Site Plan Review

Site: 27601 Southfield Road
Applicant: Oakland Development, LLC
Plan Date: September 13, 2023
Zoning: VC Village Center District

Proposal: Commercial Building Renovation

SURNOW CO. - LATHRUP VILLAGE RENOVATION 27601 SOUTHFIELD RD. LATHRUP VILLAGE, MI EXISTING SITE AERIAL VIEW

PROPOSED RENDERINGS

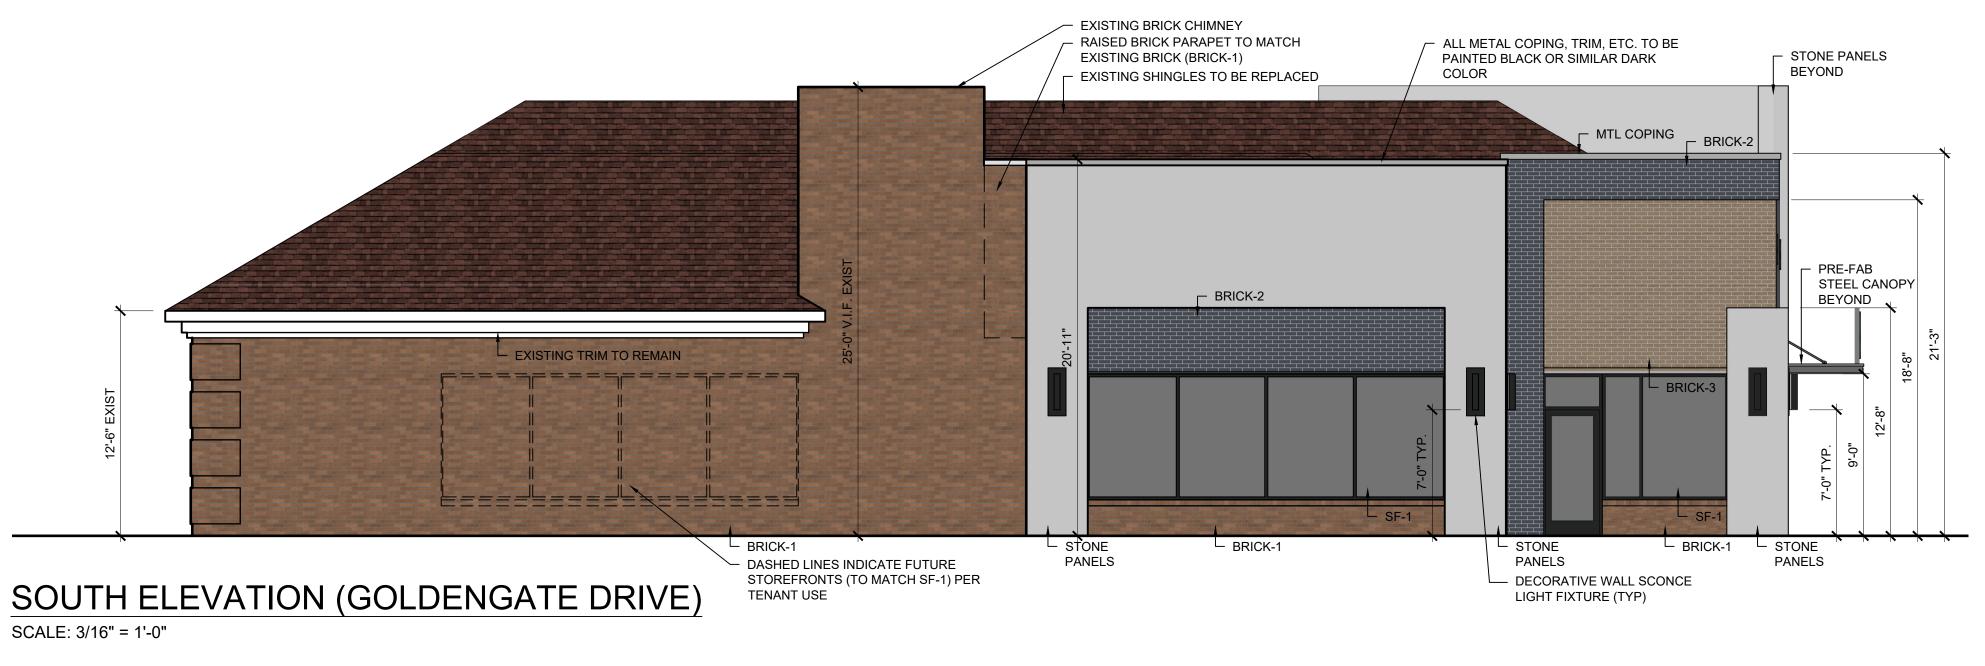
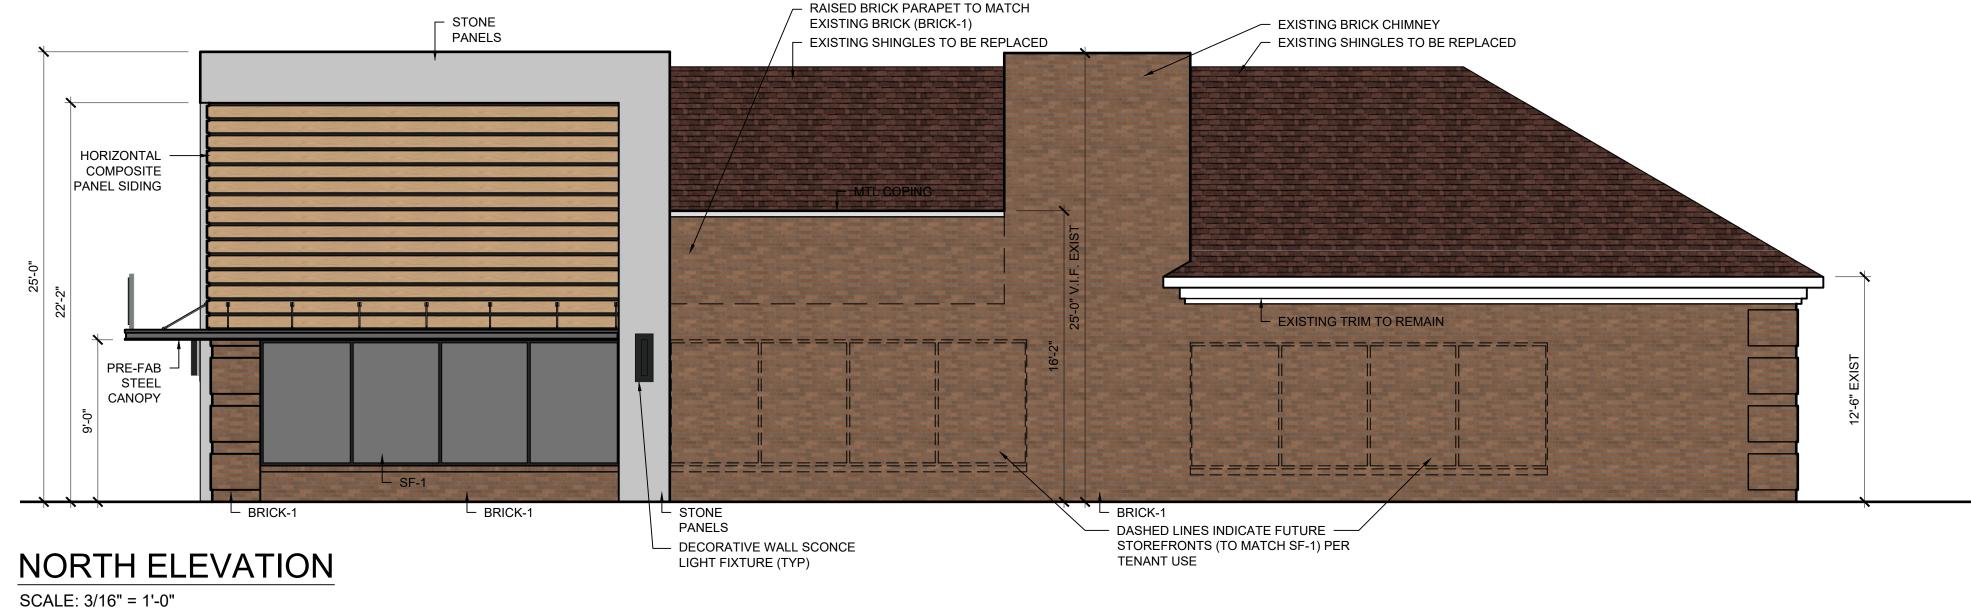
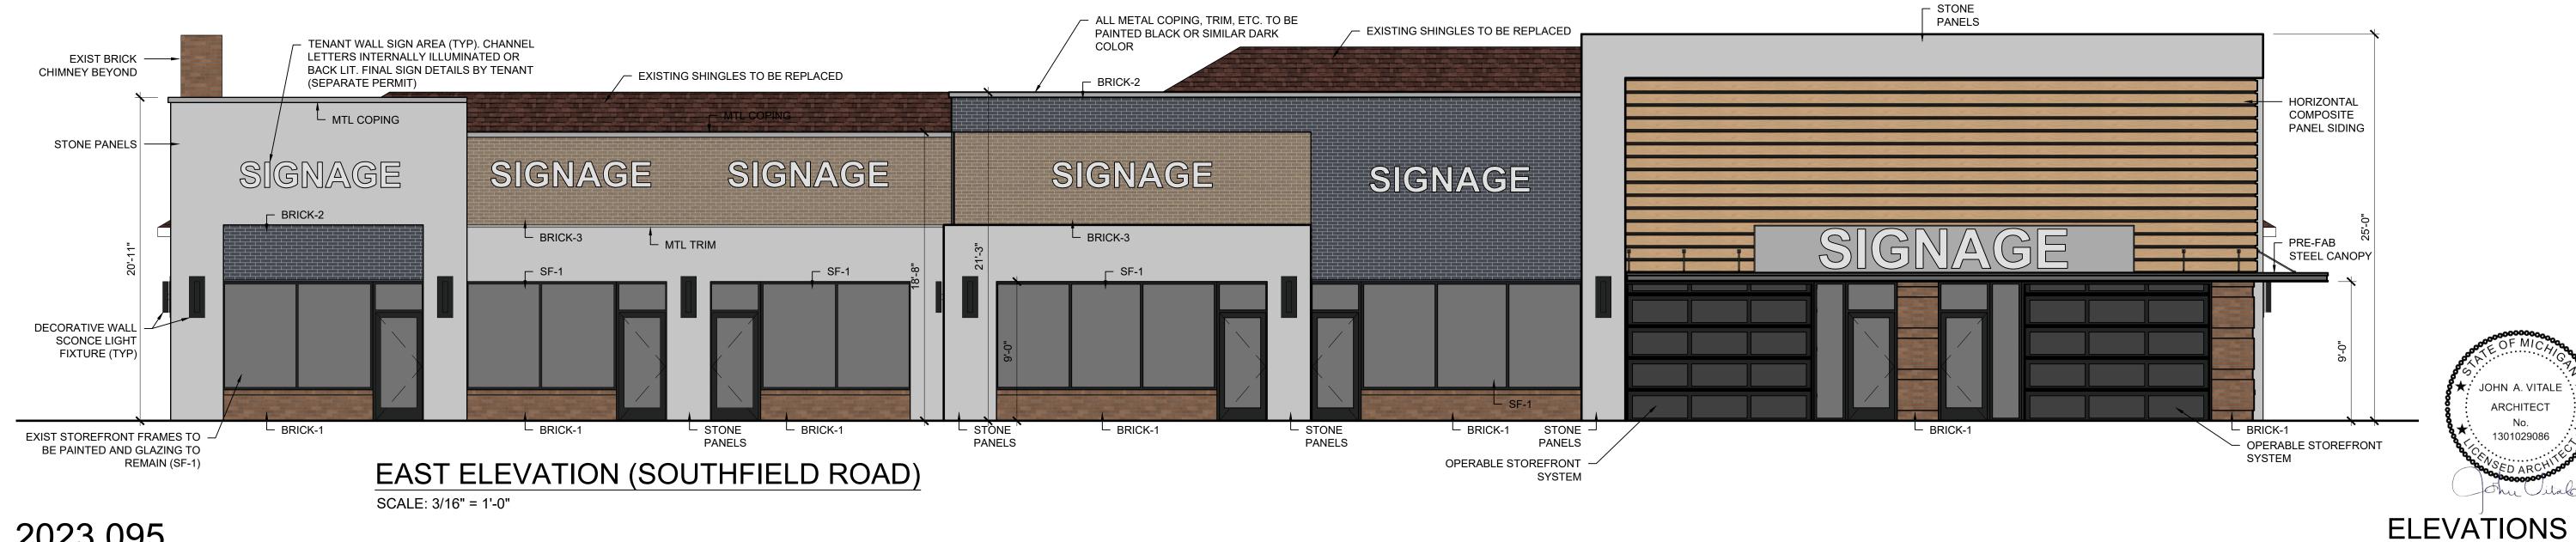
The color renderings identify the variety of materials proposed. This standard appears to be met.

There are no lighting changes noted on the site plan. The plans indicate new, wall-mounted lighting on each side of the building. The site plan shall address all new lighting fixtures and confirm this ordinance standard is met. Include a rear, west-facing building elevation that indicates any new, wall-mounted lighting that will face the single-family homes on the west side of El Dorado Drive.
